**Rezoning Application:** PD 26-0270  
**Zoning Hearing Master Date:** June 22, 2026  
**BOCC Land Use Meeting Date:** August 11, 2026

AGENCY REVIEW COMMENT SHEET

PETITION NO: RZ 26-0270

2.4 Proposed Site Plan (partial provided below for size and orientation purposes. See Section 8.0 for full site plan)

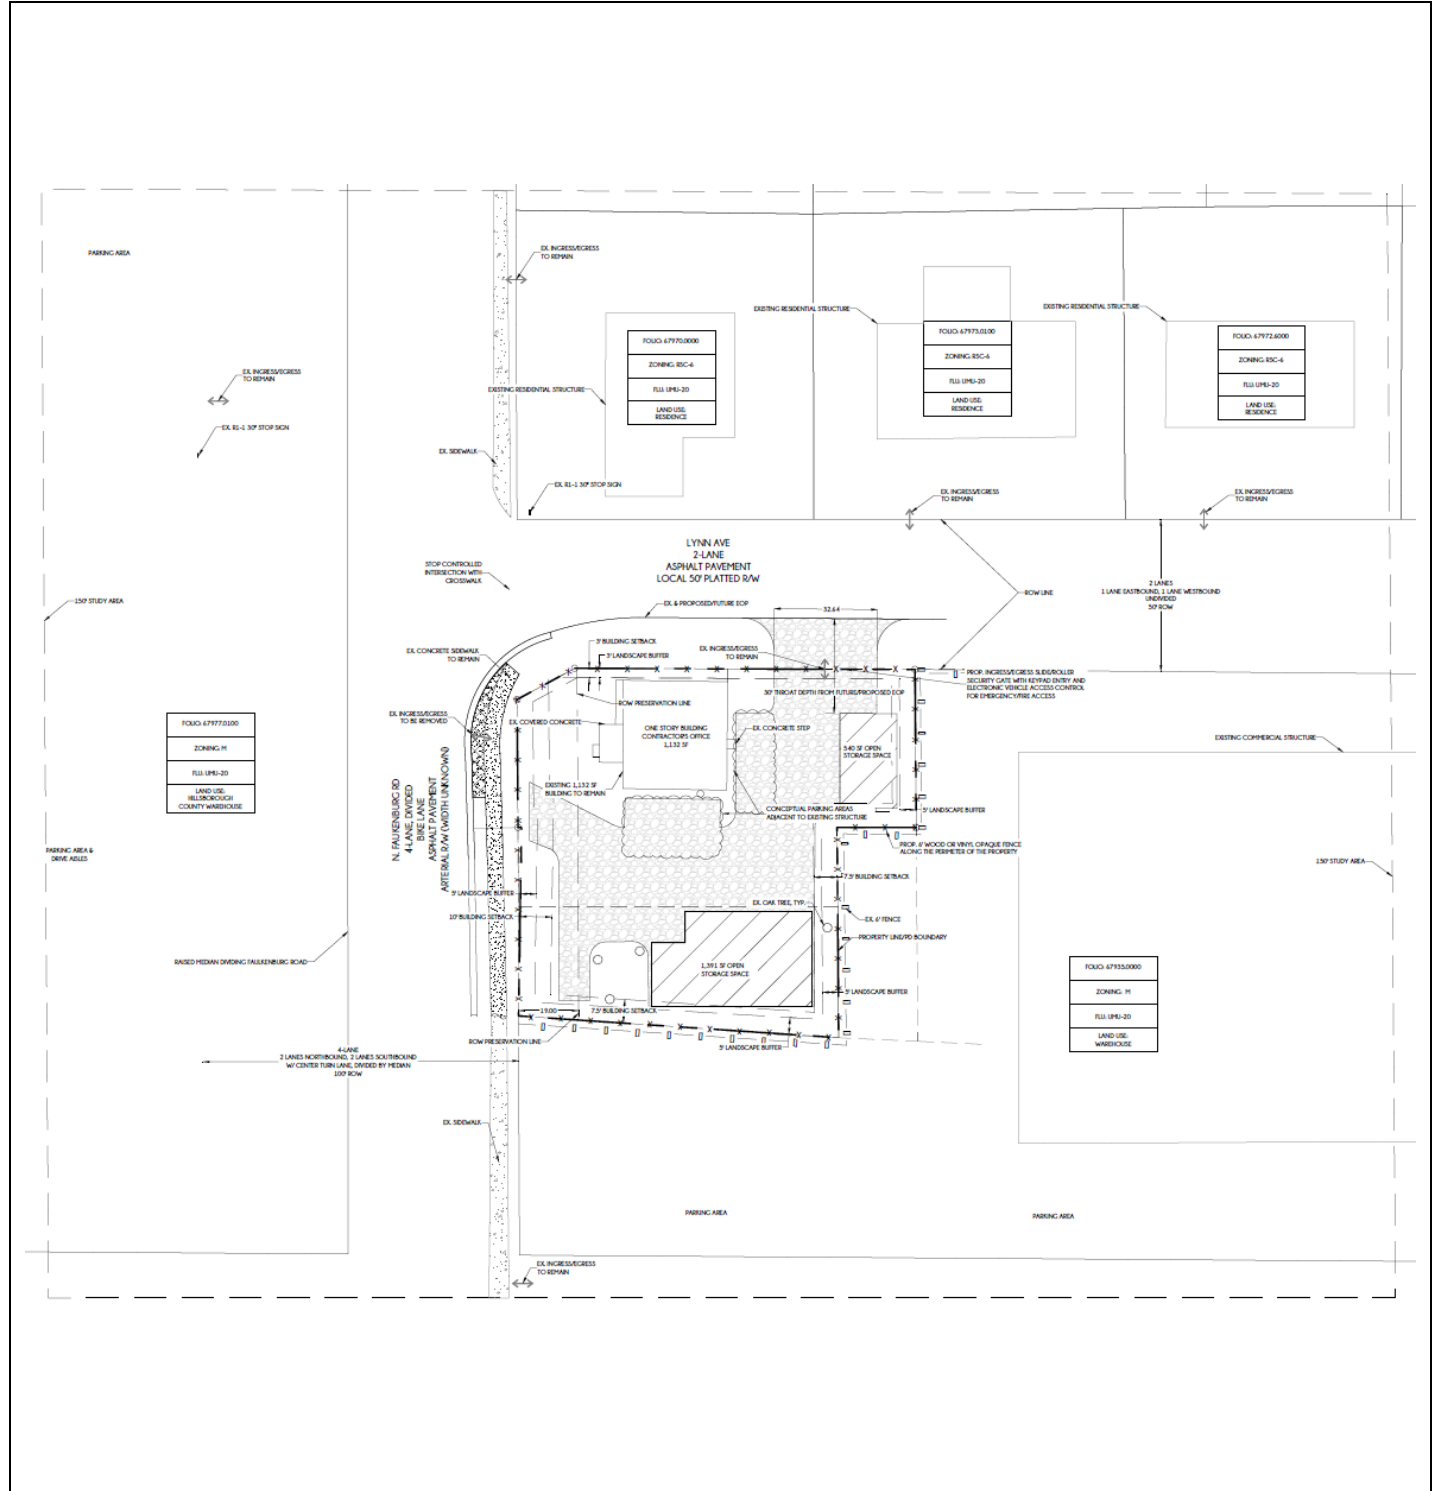
The proposed Planned Development for a Contractor's Office with associated open storage incorporates site design features intended to address compatibility with adjacent properties. The site plan retains the existing structure, and places open storage areas within the central portion of the approximately 0.27-acre parcel. A 6-foot opaque fence is located along the perimeter, providing consistent visual separation between the site and surrounding properties. Setbacks of 10 feet along N. Falkenburg Road, 7.5 feet along the south and east, and 3 feet along the Lynn Avenue frontage establish defined physical separation at the property boundaries.

Building height and overall development intensity remain low, with activities limited to the existing building footprint and designated internal storage areas. Storage functions and vehicle circulation are confined to specific portions of the site, and the perimeter fencing contributes to screening along all property lines.

The site is bordered primarily by M zoned parcels that support industrial and commercial uses, and the development layout reflects a separation between onsite storage areas and nearby properties through setbacks, fencing, and the placement of storage areas toward the interior of the site. The Lynn Avenue frontage also provides a roadway-based transition along the northern boundary. Although buffering and screening are not required along the more intensive M-zoned east and south boundaries, their inclusion on the plan serves as an added enhancement that further supports overall compatibility.

1. Development on the site shall be limited to a Contractor's Office with associated open storage, as generally depicted on the approved site plan. Open storage shall be restricted to designated areas shown on the plan and shall consist only of materials, equipment, and vehicles customarily associated with the contractor's operations. The existing commercial structure shall function as the administrative office for the use. No additional principal structures or uses shall be permitted beyond those identified on the approved plan.

A 6-foot high opaque fence shall be provided along the perimeter of the site as shown on the approved plan. Reduced buffer widths of 5 feet along the east and south property lines are permitted, and all required screening materials within these buffers, including fencing and landscaping, shall be installed and maintained to ensure adequate opacity consistent with LDC Section 6.06.06. Existing vegetation may be utilized to meet screening requirements where it provides equal or greater opacity than required, and supplemental landscaping shall be installed where existing vegetation does not meet applicable standards. Existing vegetation used for screening shall be preserved and maintained unless removal is necessary for health, safety, or permitted site development.
